URGENT - FIELD SAFETY NOTICE

**MAQUET HLX 2004-5 DF, HLX 3004-5 DF and XTEN DF
Field Action MSA/2017/002/IU**

Date: 27 March 2018

Field Correction Notice: MSA/2017/002/IU

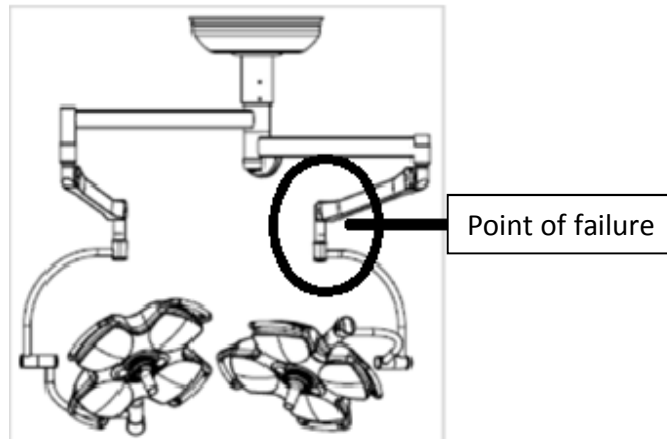
Product Issue: Breaking of AC2000 spring arms in use with HLX2004-5 DF, HLX 3004-5 DF and XTEN DF cupolas .

From our investigation it was concluded that there is a low failure rate that only can present itself on the devices of types and production identified in this letter. The issue relates to a crack in the metal of the spring arms that has the potential develop into a break. The devices are over ten years old and even so

This potential for malfunction is caused by fissures near the weld seam at the front pivot of the spring arm. The design of the spring arm was improved in 2006. The devices involved for your market are limited to those listed in the attached Consignee list.

Resolution: MAQUET proposes to replace the affected spring arms with new ones to make sure all devices present in the market are working effectively and safely.

This letter is to inform you of a corrective action that consists of replacing all potentially affected spring arms still in use with new ones. This action will be performed to prevent any possible hazard to persons and equipment.
